From: Barfield, David
Sent: Monday, August 7, 2017 1:40 PM
To: Orrin Feril
Cc: Beightel, Chris; Letourneau, Lane; Lanterman, Jeff; Perkins, Sam; Metzger, Susan; McClaskey, Jackie; Titus, Kenneth (Kenneth.Titus@ks.gov)
Subject: FW: Quivira, additional work
Attachments: Quivira_resp_chng_v1_v3.png; Quivira_Response_v3_22x34.png
Importance: High

GMD 5 expressed concerns on our so-called "seahorse map," which show the response of pumping on Zenith flows, in regard to the negative values on the fringe, esp. in the Arkansas River basin. I indicated we would review the matter and likely re-do the work.

Change in stream response between version 1 and version 3

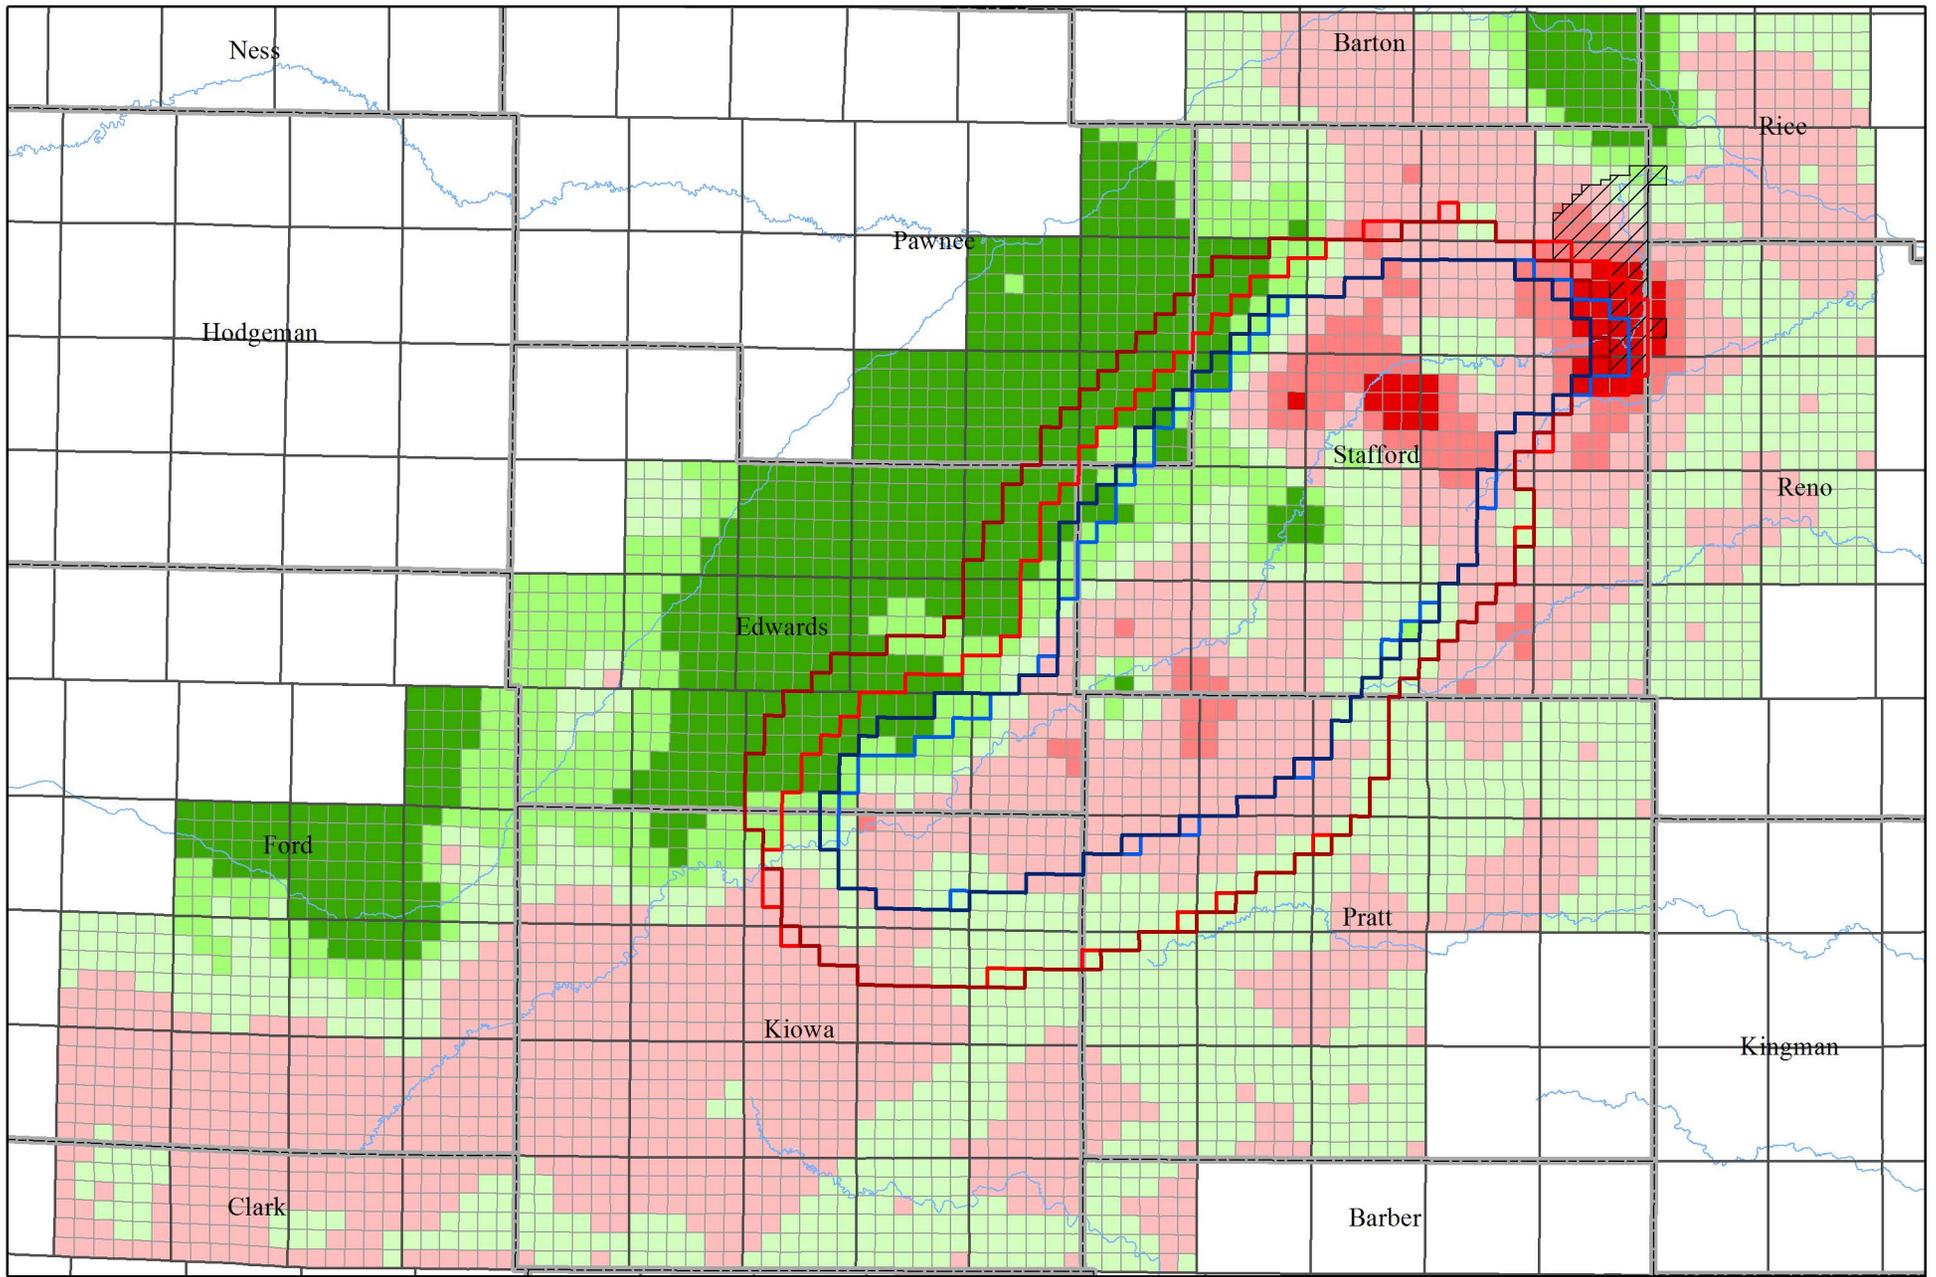
So after getting out the work we presented at our last meeting, we did review the matter in more detail. In short, we found that a simplifying assumption made to get the work out did not hold as well as we expected, esp. on the fringes of including the lower impact areas of the Arkansas River valley.

So we re-ran the modeling analysis used to create the response map without this simplifying assumption and also doubled the number of points used to create the map. This work produces a more accurate map and essentially eliminates the negative values. However, the revised work shows the area impacting Zenith is about 15% larger than previously estimated (see attached png file contrasting the previous version and the updated, more accurate version). Almost all of the expanded area is in the Arkansas River basin (very little on the Ninnenscah). Also attached is a detailed version of the new map that will make it easier for people to identify if they are in the boundary.

Fig. 3. Projected impact on RSC-Zenith streamflow for scenario 13 and with 15 and 30 percent pumping reductions within revised zone A (10 percent or greater response zone) beginning in 2018.

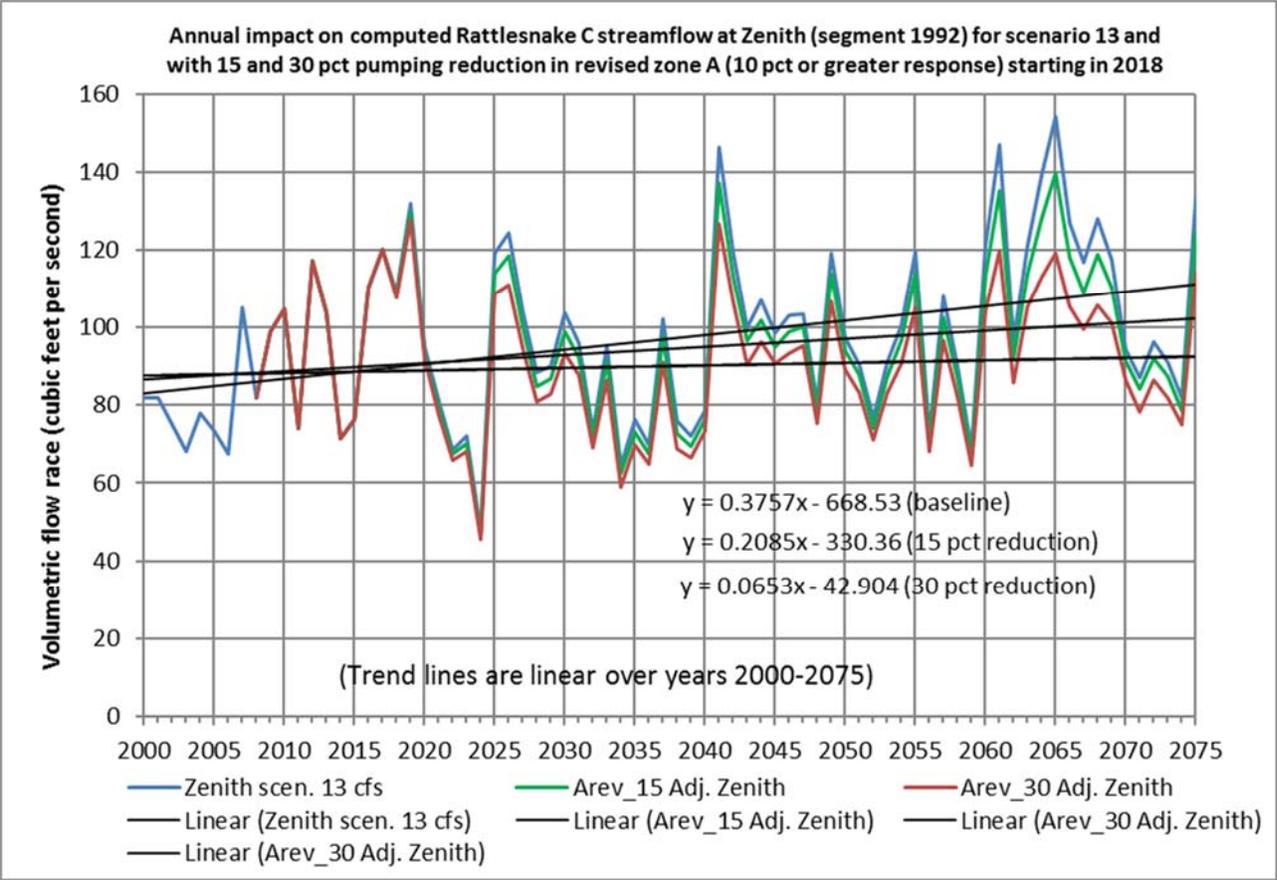
We also re-ran the revised Zone A through our future projections for both a 15% reduction (to match our proposal) and a 30% reduction. With the larger area, the trend in projected, future streamflow under the 30% reduction is now flat line, as opposed to slowly declining.
